Eldridge Park

Eldridge Park is very large neighborhood park that provides walkways, playgrounds, picnic areas, tennis courts, a grill, sledding hill, soccer fields, ballfield and preschool building. The main issues at this park are accessible routes, slopes, not properly marked accessible parking spaces, protruding branches. The preschool building has been upgraded for accessibility and could with some upgrades be a designated accessible preschool site. **Please Note:** When a **UD** is indicated, this is a Universal Design (**UD**) recommendation to enhance accessibility. The **UD** recommendation is not required to meet the minimum accessibility standards but it would be encouraged.

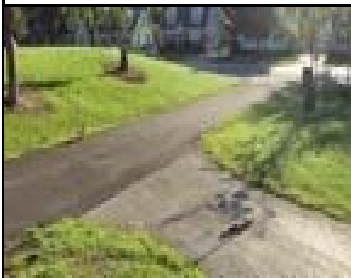
The curb ramp up to the walkway has an abrupt transition of 1".	ADAAG 406	Provide a curb ramp with a running slope no steeper than 8.3% and a cross slope no steeper			\$275	2017	Added Curb Ramp as part of Eld ADA project April, 2017 \$60,00

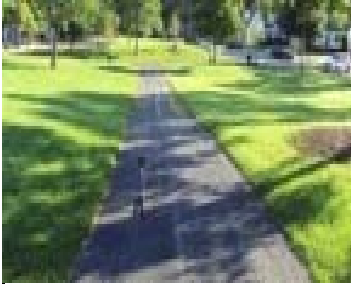
Photo	Barrier	ADAAG/IAC	Solution	Priority	By Whom	Projected Cost	Projected Date	Action Taken
	The curb ramp up to the walkway has a 3/4" gap.	ADAAG 406	than 2% and a smooth transition to the sidewalk and street gutter and fill in the gap at the gutter.			\$275	2017	Added Curb Ramp as part of Eld ADA project April, 2017 \$60,00
	The walkway along the parking has a cross slope too steep at 2.6% to 12.0% for 349'.	ADAAG 403.3	Remove and regrade section to provide a cross slope no greater than 2%.			\$11,525	2014	Path improvement to meet standards 6/2014 \$15,000
	The walkway up to the southeast stairs has sections that are broken and uneven and has a cross slope too steep at 2.6% to 4.0% for 88'.	ADAAG 403.3	Remove and regrade section to provide a cross slope no greater than 2%.			\$2,900	2014	Path improvement to meet standards 6/2014 \$15,000
	The curb ramp near the southeast stairs does not have truncated domes.	ADAAG 705	Provide truncated domes that go the width of the sidewalk and 24" deep where it meets the road. Provide a color that contrast with the walkway surface. Truncated dome tiles are typically a more durable solution.			\$500	2017	Remove curb and replace with mountable curb, not a pedestrian crossing, should not have TDs. 4/2017

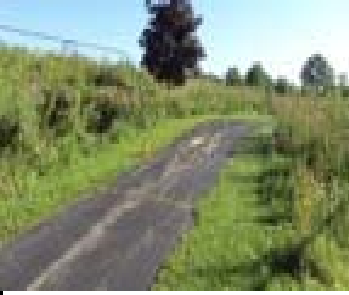
Photo	Barrier	ADAAG/IAC	Solution	Priority	By Whom	Projected Cost	Projected Date	Action Taken
	The walkway hill up to the playground has a running slope too steep at 5.6% to 13.9% for 84'.	ADAAG 403.3	Because of the terrain in this area meeting sloped walkway or ramp slopes may not be possible. When replacing, remove and re-grade to the least running slope possible. However do provide a cross slope not steeper than 2%. Make sure the other walkway that does provide an accessible route to the upper walkway area does meet code requirements. See			NA	2022	
	The walkway hill up to the play ground has a cross slope too steep at of 2.6% to 7.2% for 56'.							
	The walkway near the accessible parking that is the accessible route up to the upper walkway area has a cross slope too steep at the intersection of 2.6% to 5.8% for 19'.	ADAAG 403.3	Regrade section to provide a cross slope no greater than 2%.			\$625	2014	Path improvement to meet standards 6/2014 \$15,000

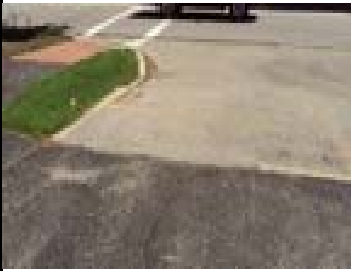
Photo	Barrier	ADAAG/IAC	Solution	Priority	By Whom	Projected Cost	Projected Date	Action Taken
	The adult/older child swings have a slope too steep at 23.9% to 25.5%	ADAAG 1008.4.4	Provide a regular maintenance to the play surface to provide a seat less than 24" off the ground and a slope under the swings no greater than 2%. Consider a mat under the swing to prevent kick-out of surface material. An accessible swing with a seat would be recommended at some point.			\$100	2020 as part of Playground replacement	
	The curb ramp slope into the 2-5 year old playground surface is too steep at 18.2%.	ADAAG 1008.2	Provide a curb ramp from the accessible walkway to the playground surface with a running slope no steeper than 8.3% and an cross slope no steeper than 2%.			\$1,500	2020 as part of Playground replacement	
	The transfer platform at the 2-5 year old playground is too high at 20 1/2".	ADAAG 1008.3.1.2	Regrade some engineered wood fiber to provide a transfer platform height between 11" to 18" AFF. Provide a regular maintenance of this surface.			\$100	2020 as part of Playground replacement

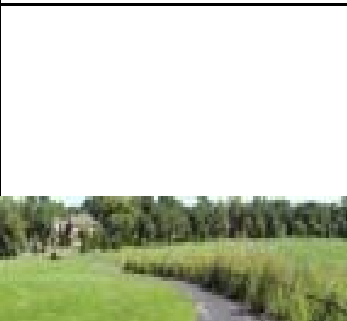
Photo	Barrier	ADAAG/IAC	Solution	Priority	By Whom	Projected Cost	Projected Date	Action Taken
	Two picnic tables are provided but only one is of an accessible design.	Proposed Outdoor Developed Areas Guidelines ADAAG 245 & 1011	Picnic Table Recommendation: At least 20% of picnic tables, but no less than two, be of accessible design, connected to an accessible route. Relocate or purchase two accessible picnic tables (\$750/each) and locate them on an accessible surface (\$900).			\$1,000	2020 as part of Playground replacement	
	No accessible route is provided to the grill and picnic table for 28'.	ADAAG 403.3	Provide a new accessible route with a running slope no steeper than 5% and a cross slope no steeper than 2% and a minimum clear width of 36".			\$1,000	2020 as part of Playground replacement	
	The cross slope of the walkway along the tennis courts and parking has a cross slope too steep at 2.6% to 11.6% for 155'.	ADAAG 403.3	Regrade section to provide a cross slope no greater than 2%.			\$5,125	2023

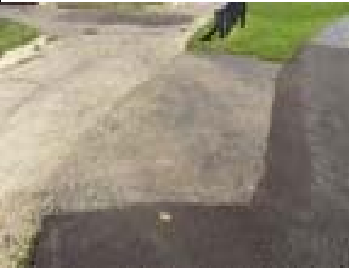
Photo	Barrier	ADAAG/IAC	Solution	Priority	By Whom	Projected Cost	Projected Date	Action Taken
	The north walkway west of the northeast entrance has a cross slope too steep at 2.6% to 8.0% for 130'.	ADAAG 403.3	Remove and regrade section to provide a cross slope no greater than 2%.			\$4,300	2023	
	The intersection of the north walkway at the sledding hill east walkway has a cross slope too steep at 2.6% to 7.2% for 163'.	ADAAG 403.3	Remove and regrade section to provide a cross slope no greater than 2%.			\$5,375	2023	
	The north entrance to the park at the sledding hill east walkway has a cross slope too steep at 2.6% to 7.0% for 53'.	ADAAG 403.3	Remove and regrade section to provide a cross slope no greater than 2%.			\$1,750	2023	
	The east walkway up to the top of the sledding hill has a slope of 5.6% to 8.9% for 109'.	ADAAG 405.6 and ADAAG 405.7	Because of the length of this ramp have three landings every 30' that are 60" minimum in length and the width of the walkway to provide a resting area. Consider this side the accessible side.			\$825	2023

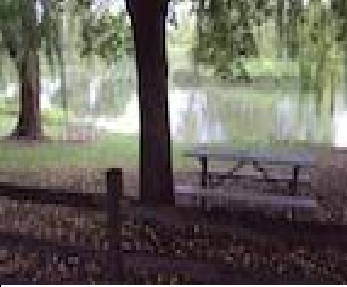
Photo	Barrier	ADAAG/IAC	Solution	Priority	By Whom	Projected Cost	Projected Date	Action Taken
	The running slope of the walkway at the curve is too steep at 5.6% to 7.7% for 15'.	ADAAG 403.3	running slope no greater than 5% and an cross slope no greater than 2%.				2023	
	The northwest entrance does not provide truncated domes.	ADAAG 705	Provide truncated domes that go the width of the sidewalk and 24" deep where it meets the road. Provide a color that contrast with the walkway surface. Truncated dome tiles are typically a more durable solution.			\$500	2023	
	The cross slope of the west walkway along the sledding hill is too steep at 2.6% to 4.2% for 40'.	ADAAG 403.3	Regrade section to provide a cross slope no greater than 2%.			\$1,325	2023	
	The west walkway from the back of the sledding hill to the middle walkway has a cross slope too steep at 2.6% to 5.3% for 158'.	ADAAG 403.3	Regrade section to provide a cross slope no greater than 2%.			\$5,225	2023
